27 October 2023  
Our File Ref: B23312AL001  
Contact: Bridget Wouts

RE: **LINK ROAD MIXED USE PRECINCT – BANKSTOWN AIRPORT**  
**AIRPORT SAFEGUARDING ASSESSMENT – PRELIMINARY ASSESSMENT**

L+R Airport Consulting were engaged by Bankstown Airport Limited (BAL) to undertake an airport safeguarding assessment at key design documentation stages through the Major Development Plan process as it relates to Bankstown Airport against the National Airports Safeguarding Framework (NASF) Guidelines. This assessment is based on the Preliminary Documentation stage.

**BANKSTOWN AIRPORT LIMITED**  
**LINK ROAD MIXED USE PRECINCT - AVIATION ASSESSMENT**  
**PANS-OPS SID BANKSTOWN EIGHT DEP RWY 11C & 29C**

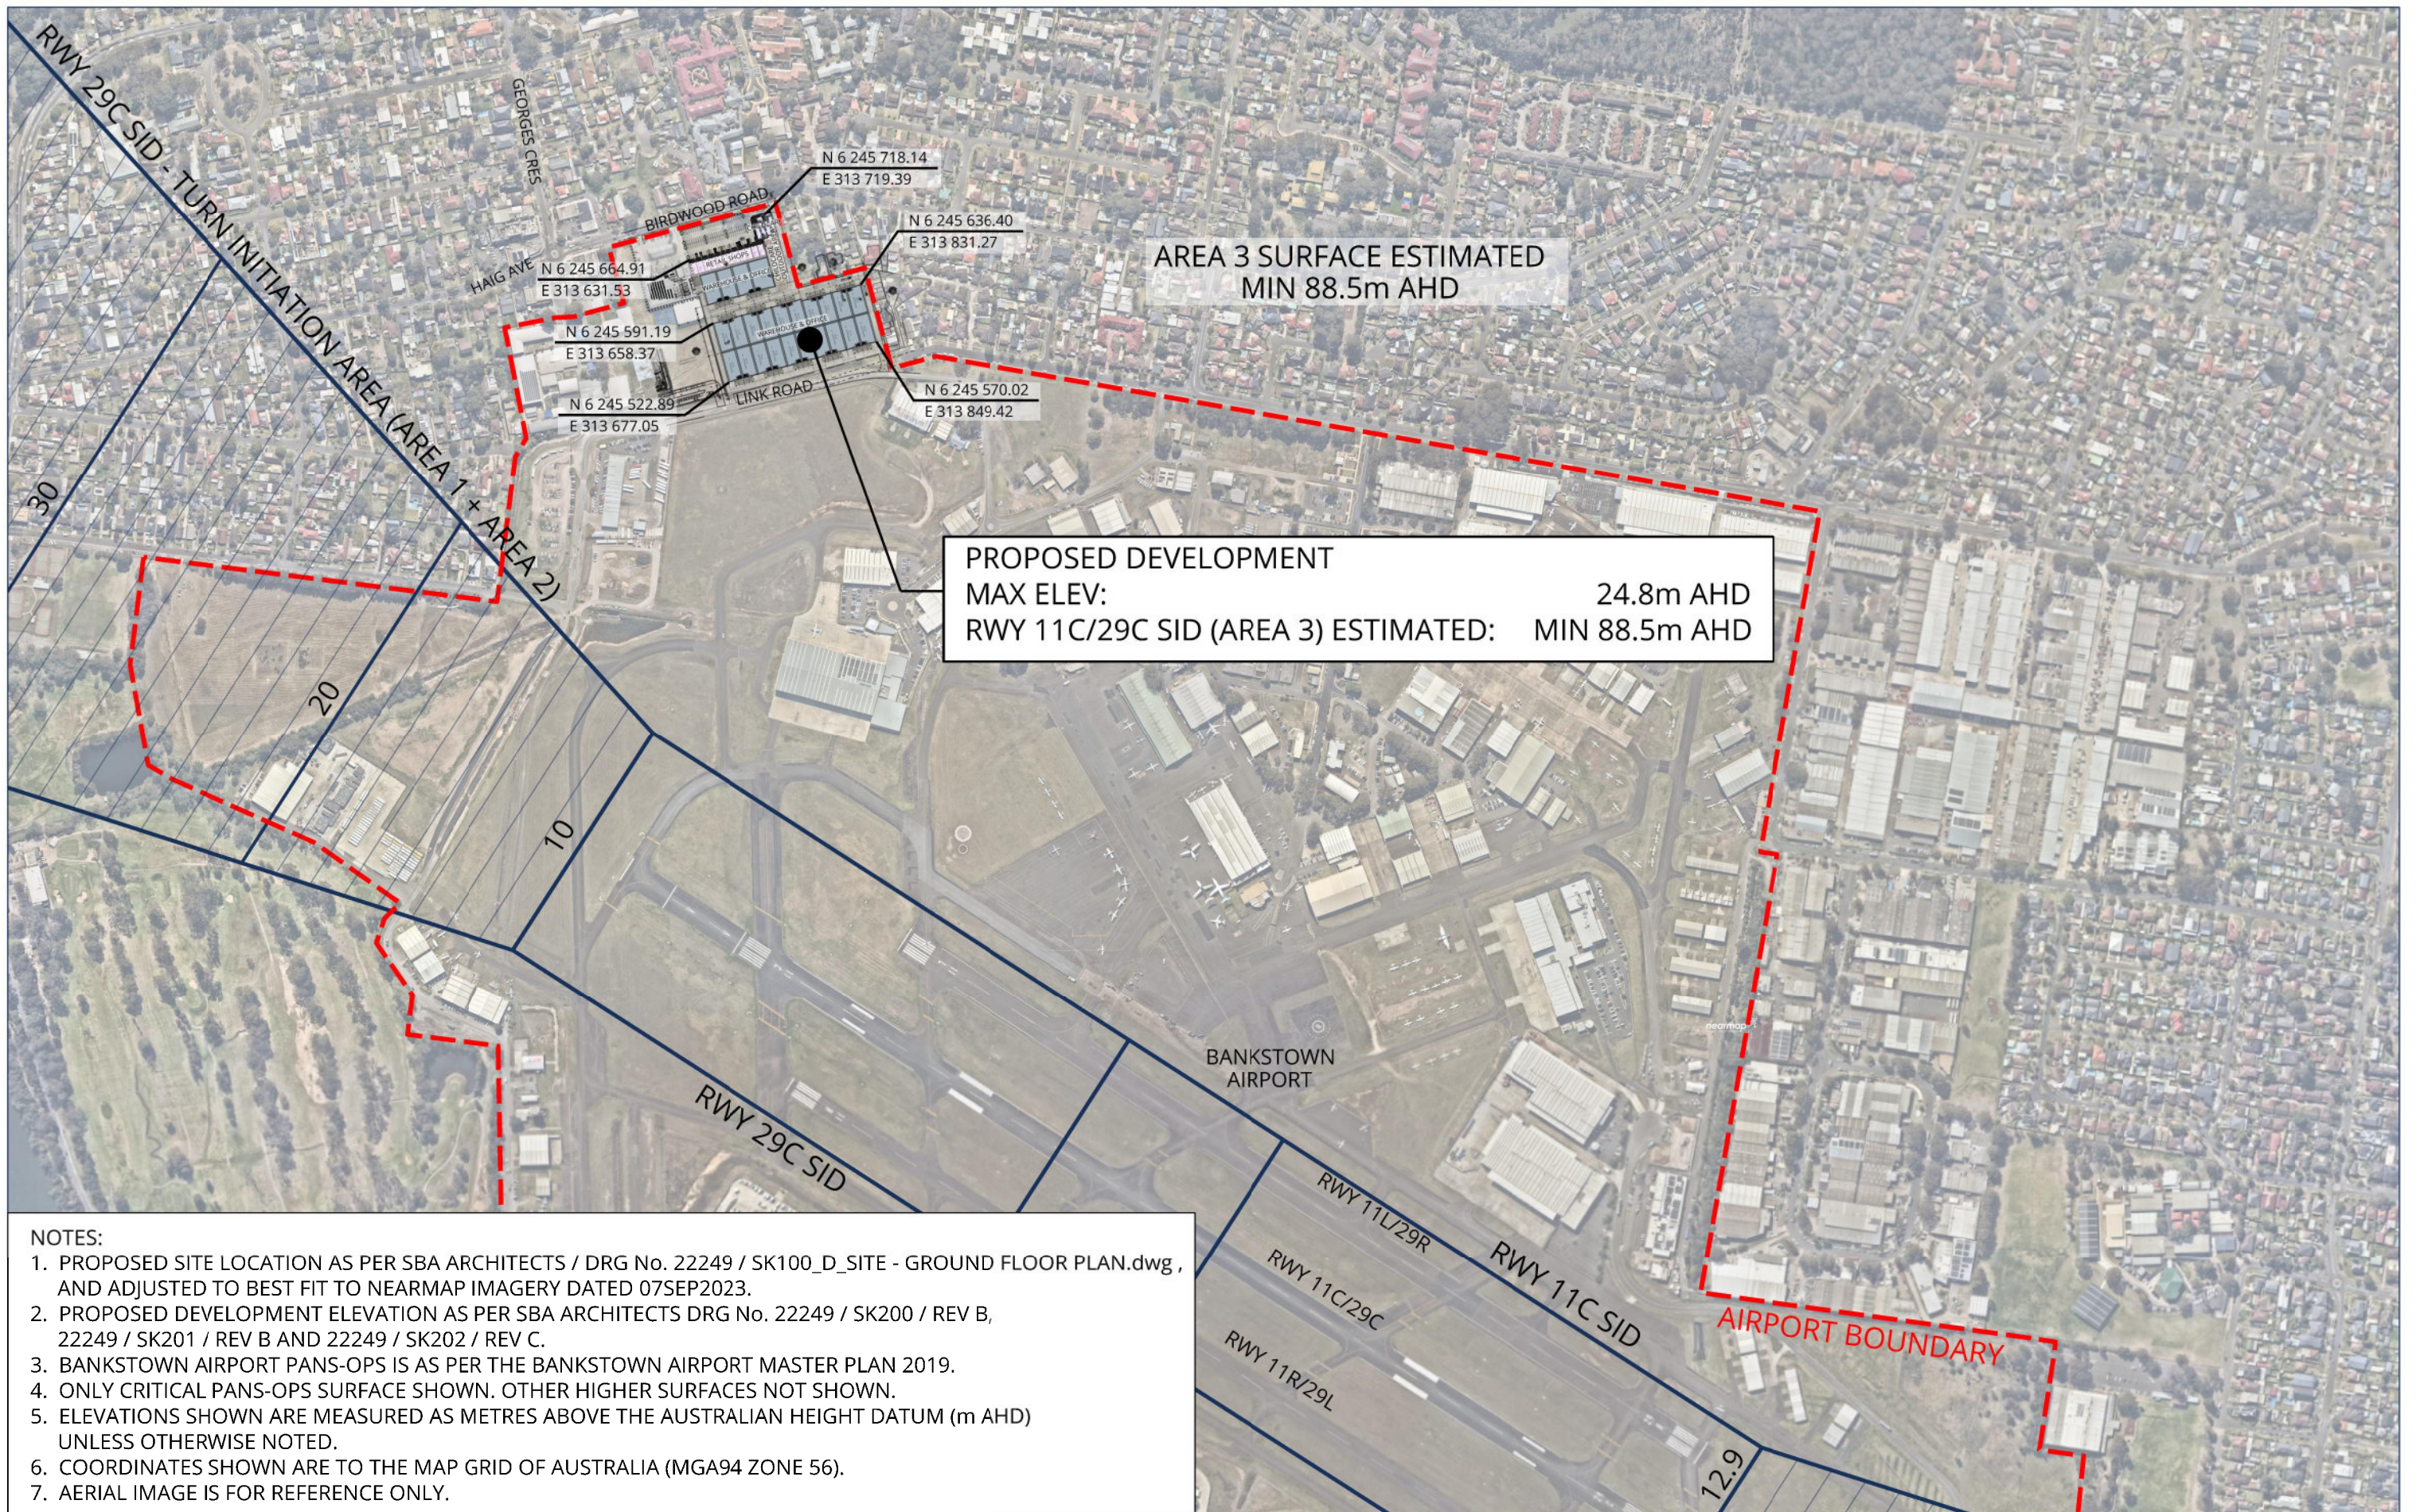
The proposed development lies within the extents of the existing Bankstown Airport PANS-OPS Runway 11C and 29C Standard Instrument Departure (SID) turn area (Area 3) as illustrated on Figure B23312/04.

The proposed development maximum elevation at 24.8 m AHD should remain below the SID Area 3 protection surface which we have estimated to be at a minimum of 88.5 m AHD. However, the proposed development must be submitted to Airservices Australia for formal assessment and confirmation of any impacts on its procedures and facilities.

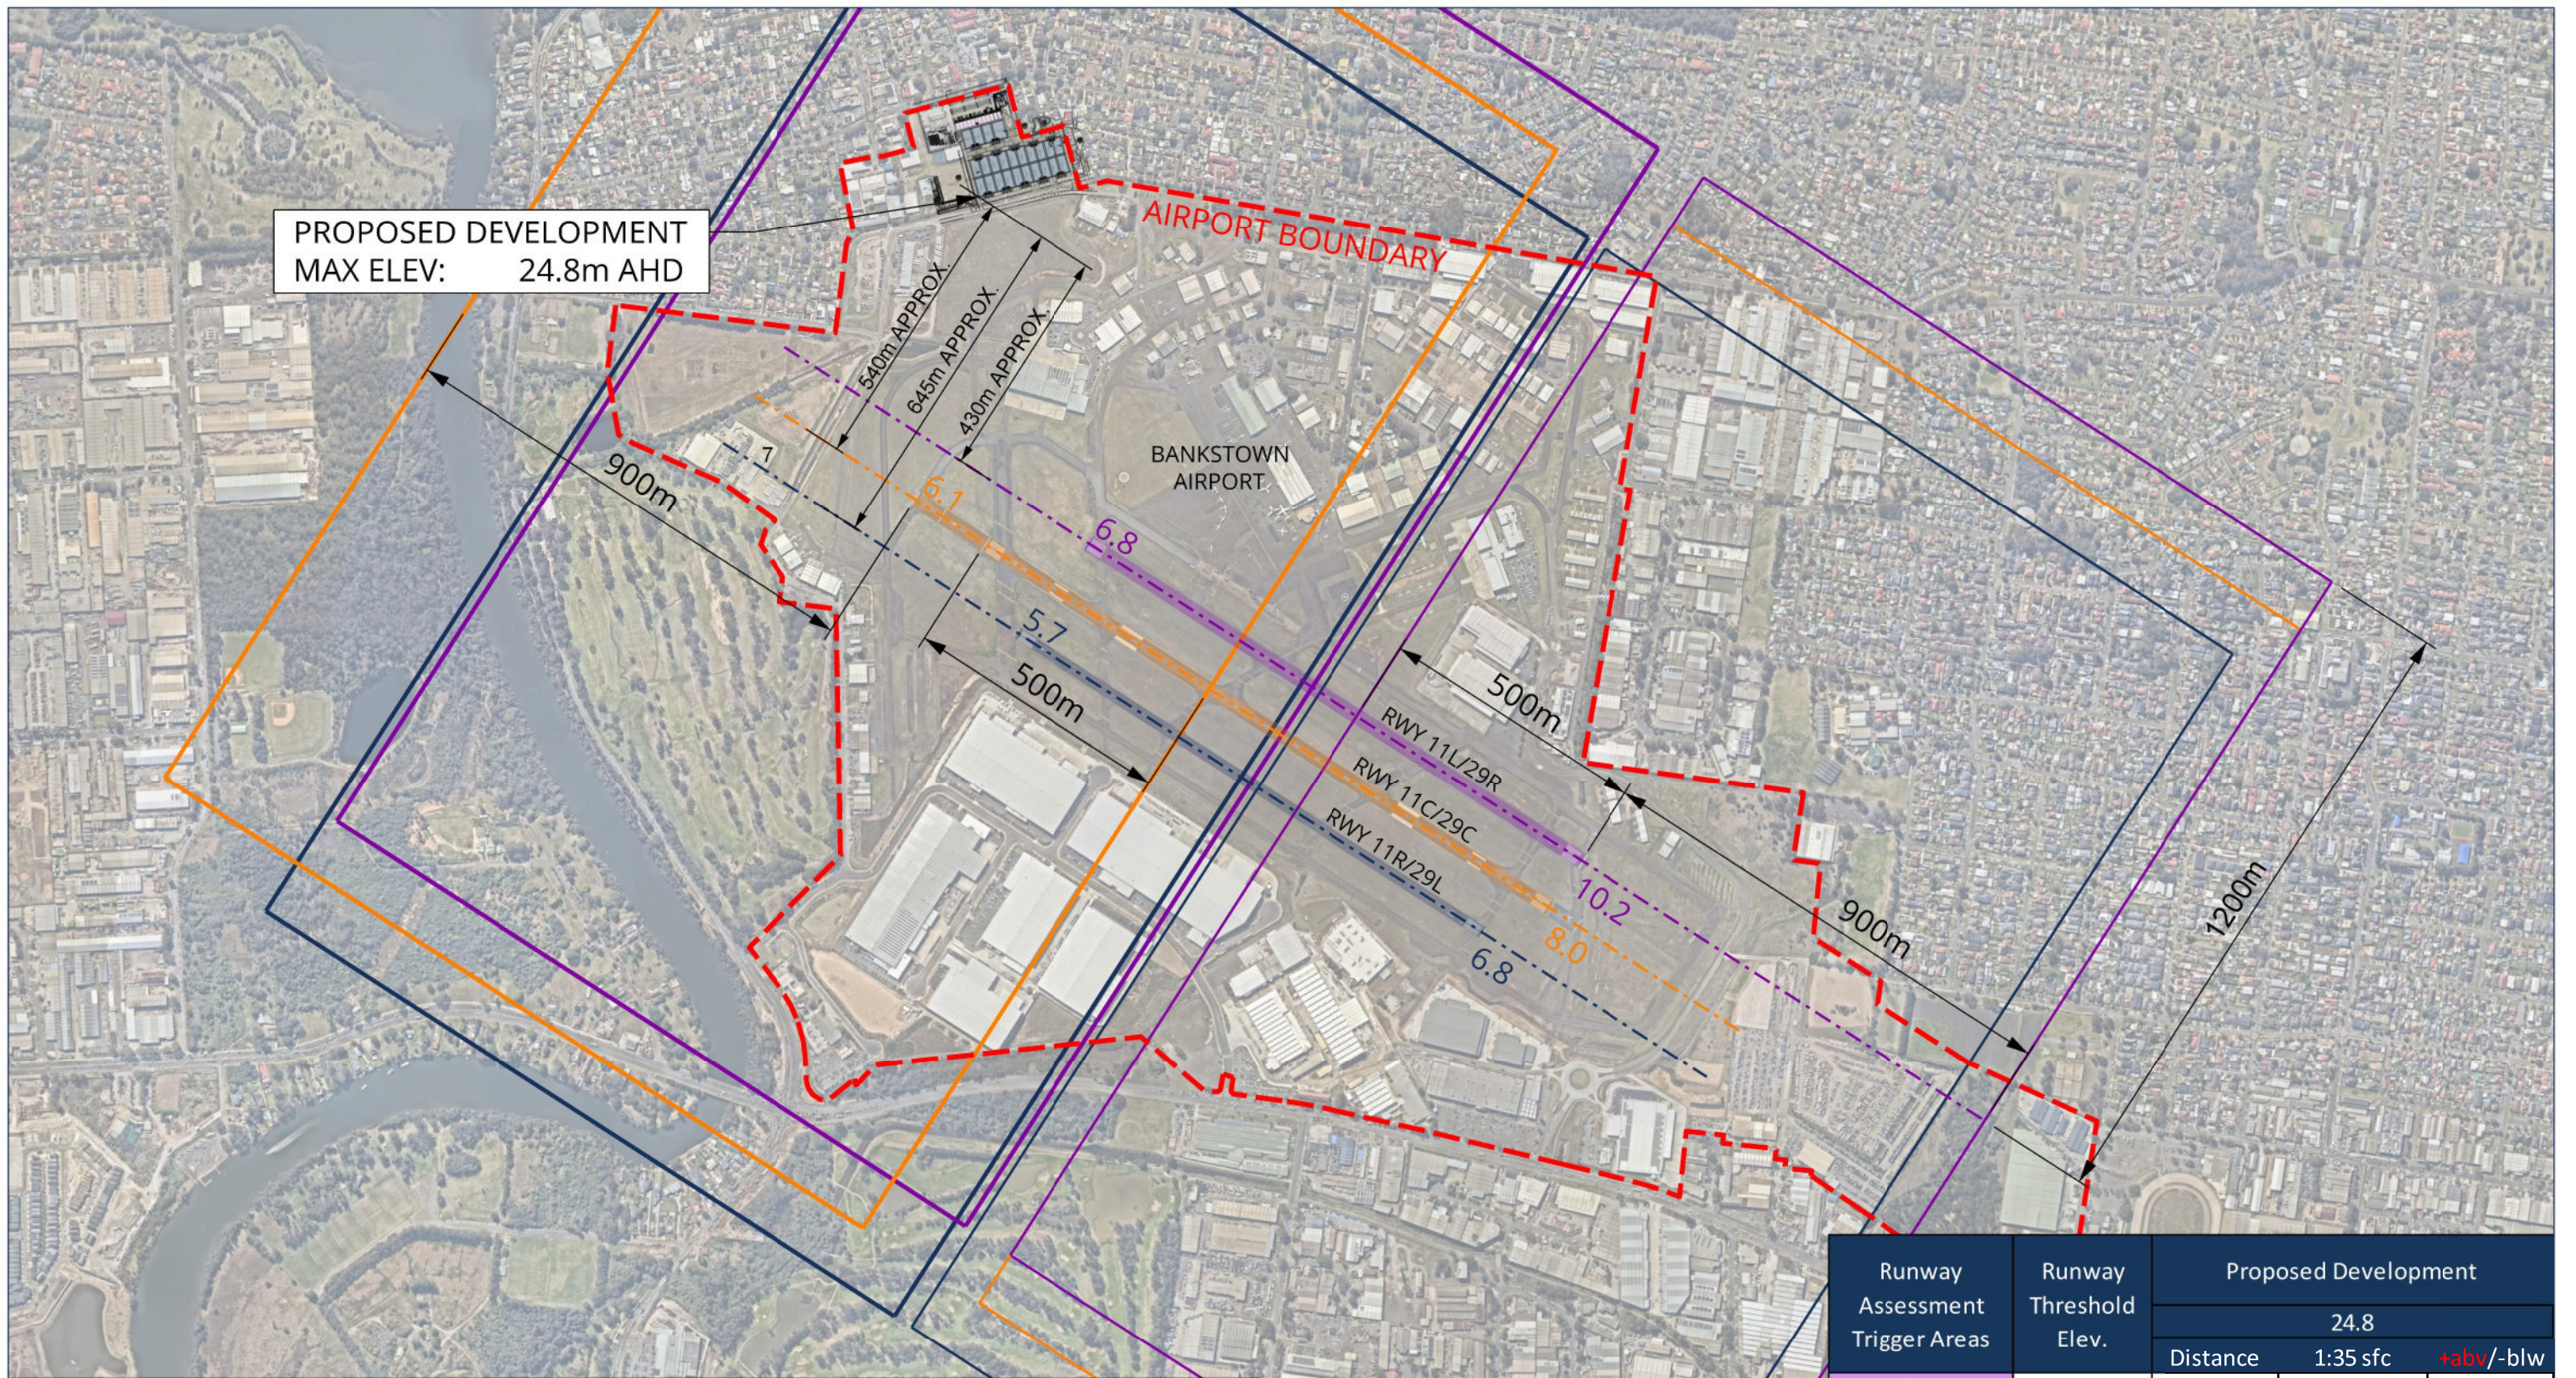
The proposed warehouse lies within the assessment trigger areas for Runways 11L, 11C and 11R as illustrated on Figure B23312/07.

For developments within the assessment trigger areas Guideline B then refers to the mitigation of risk by use of a 'height multiplier' (the 1:35 surface) determining that if buildings do not exceed the 1:35 surface they will not create unsafe wind effects. That is, the distance from the runway centreline or extended centreline to the closest point of the building should be more than 35 times the height (above runway level) of the building.

The proposed building at a maximum elevation of 24.8m AHD would infringe the 1 in 35 surface for Runways 11L, 11C and 11R by maximum of approximately 5.7 m as shown in Table 1 below. Therefore in accordance with Guideline B further assessment is required.

However, there are a number of existing buildings that lie between the proposed development and the extended runway. I will be for Bankstown Airport Limited in consultation with CASA to determine the appropriate further assessment required.
